**PD Modification Application: PRS 23-0502**

**Hillsborough County Florida**

**Development Services Department**

**Applicant:** Colonnade Crosstown LLC

### 2.4 Proposed Site Plan (partial provided below for size and orientation purposes. See Section 8.2 for full site plan)

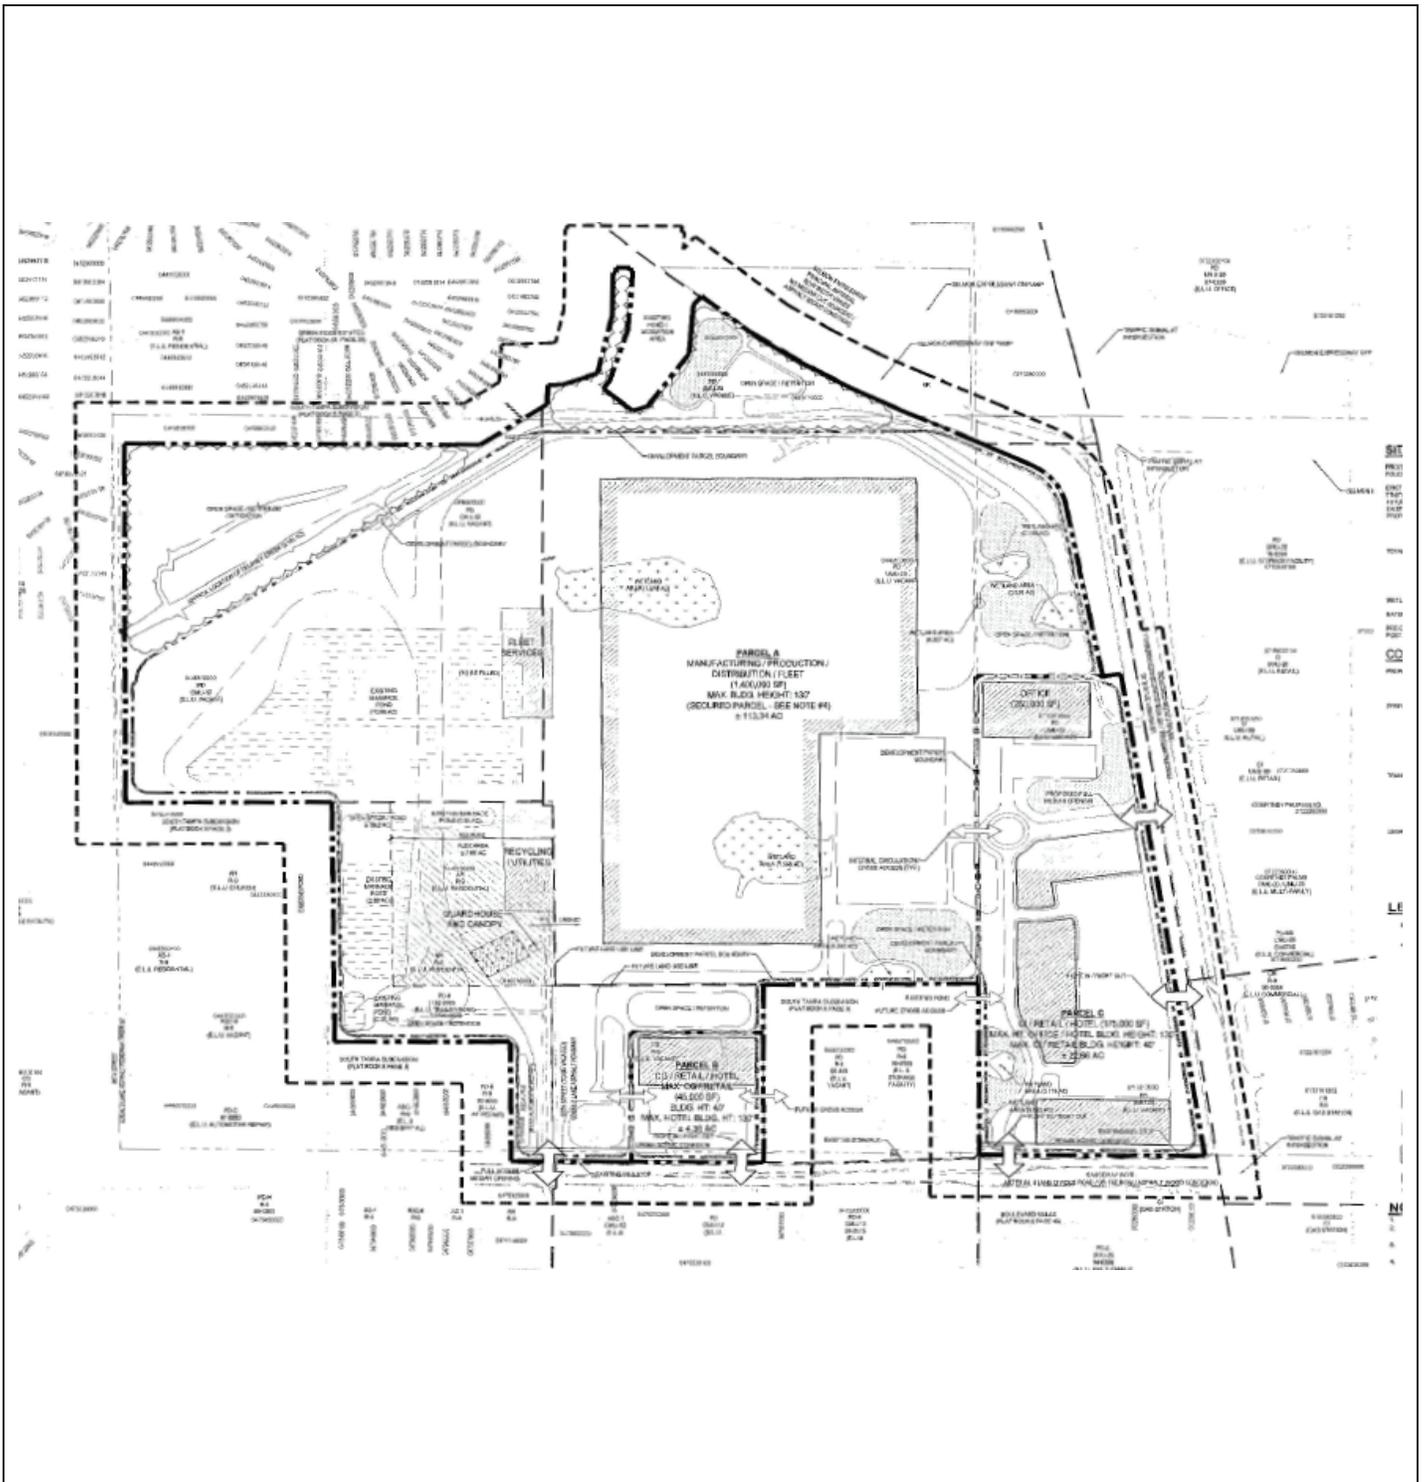
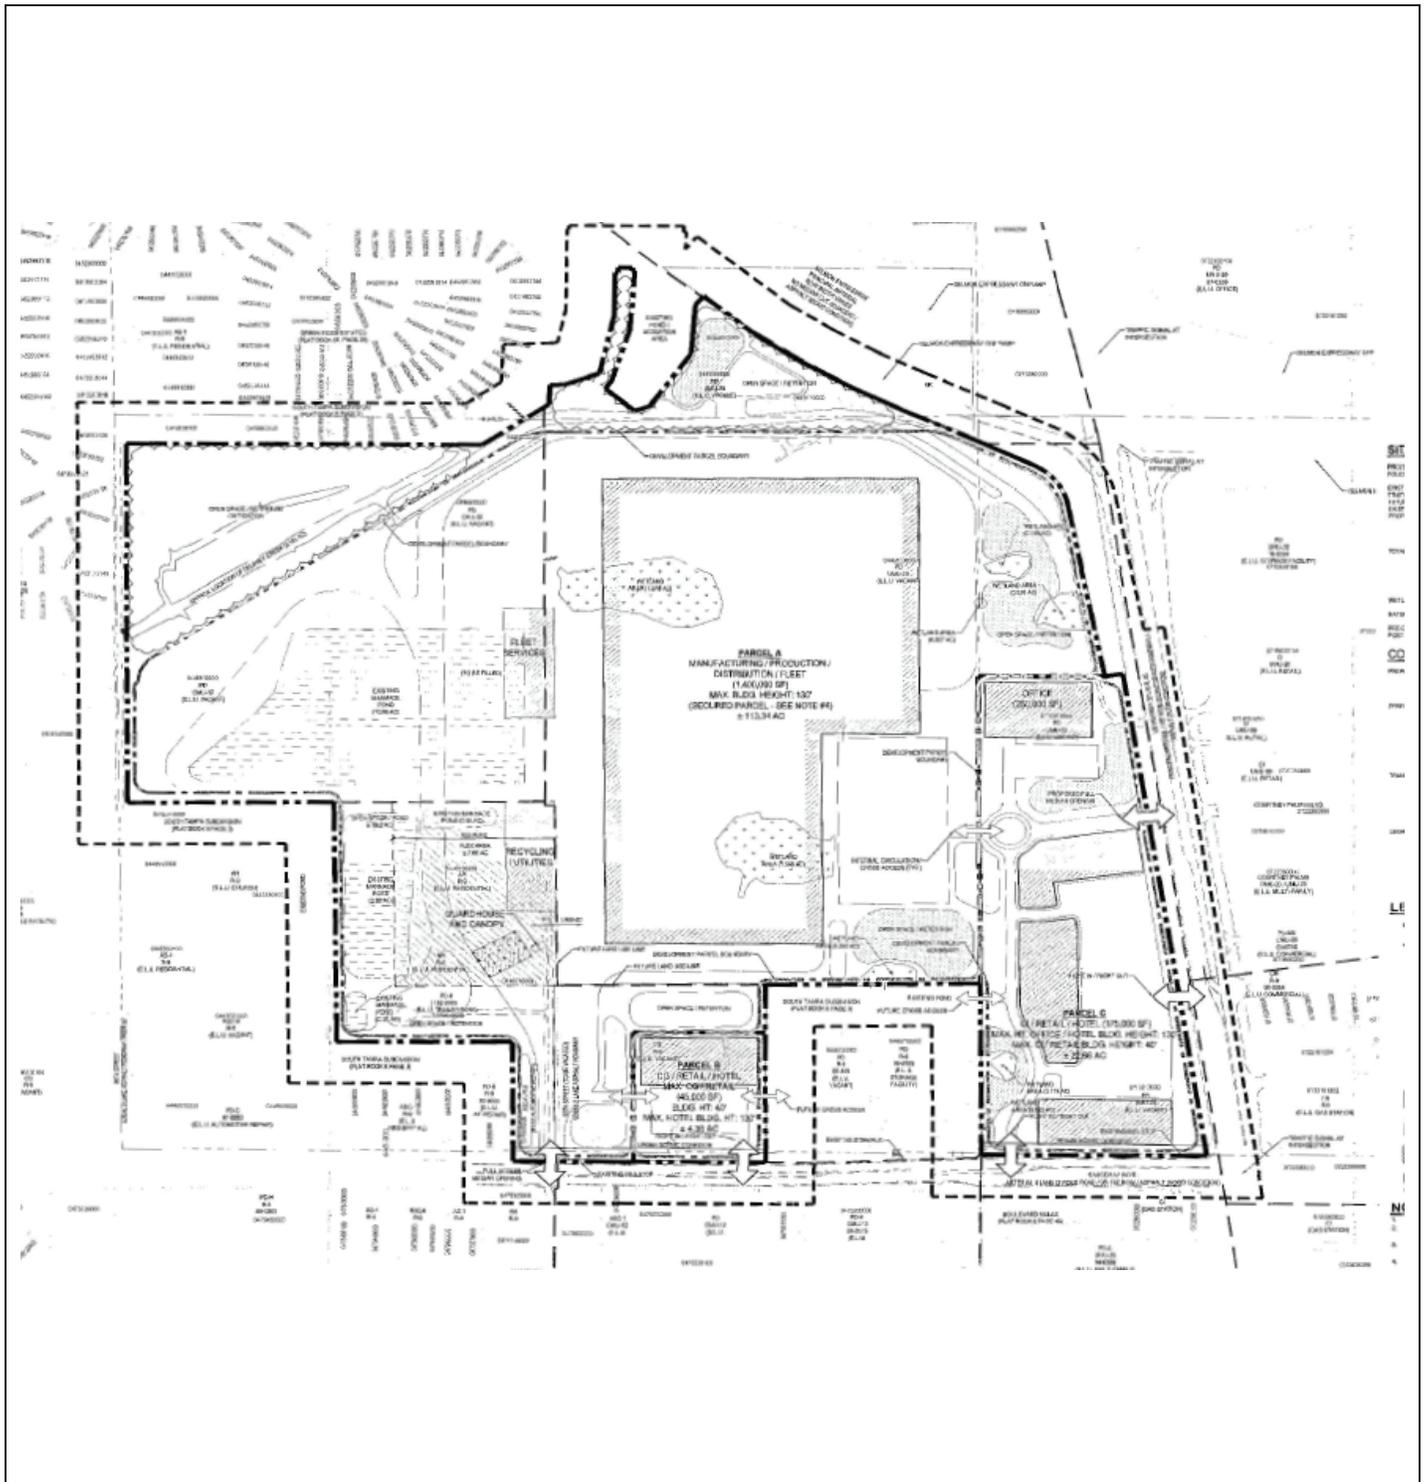
The applicant states that providing the sidewalk is difficult due to existing conditions and necessary related improvements. Existing drainage swales limit the ability to provide the sidewalk adjacent to the roadway. To improve the roadway drainage, from the existing drainage swales, it will require a complete rebuilding of the roadway pavement section, the addition of an underground stormwater conveyance system, and the installation of concrete curbing. The alternative of providing the sidewalk further into the property, on the other side of drainage swale, would place the sidewalk on private property and the removal of existing oak trees.

Should the sidewalk be provided, it would need to cross Delany Creek, which has insufficient width to provide the sidewalk. Therefore, a separate pedestrian bridge would be needed. The pedestrian bridge would need to be designed in a manner that would not impede the creek's flow or decrease the floodplain storage volume. This would prohibit the use of piers and instead require the construction of a metal bridge section. Construction of such a bridge would require the use of a large crane. The presence of overhead power lines and existing trees would pose safety concerns when operating the crane in this area.

Transportation staff has reviewed the request and applicant's justification and has no objections to removal of the sidewalk requirement.

Staff is supportive of the removal of the referenced FAR numbers. The site is approximately 158 acres in size with the total approved square footage of 1,870,000 (0.27 FAR) – which is significantly lower than the maximum which could have been approved. The site is within three Future Land Use (FLU) categories – UMU-20, CMU-12 and RES-9. Additionally, a flex of the UMU-20 FLU category was approved. The resulting maximum square footage for the 158 acre project with these three FLU categories, and the flex, is 5,573,937 (0.80 FAR). Given this, the parcel specific FAR requirements are not necessary and when project land is dedicated and conveyed for roadways per FDOT, a project may be misinterpreted as exceeding the Planned Development's FAR maximums.

17. The developer shall construct a minimum 5-foot-wide sidewalk along the entirety of the project's U.S. Highway 301 only and ~~South 86th Street~~. Subject to Hillsborough County and FDOT approval, a minimum 5-foot wide boardwalk may be permitted in lieu of the sidewalk along Highway 301 provided such facility meets ADA requirements.
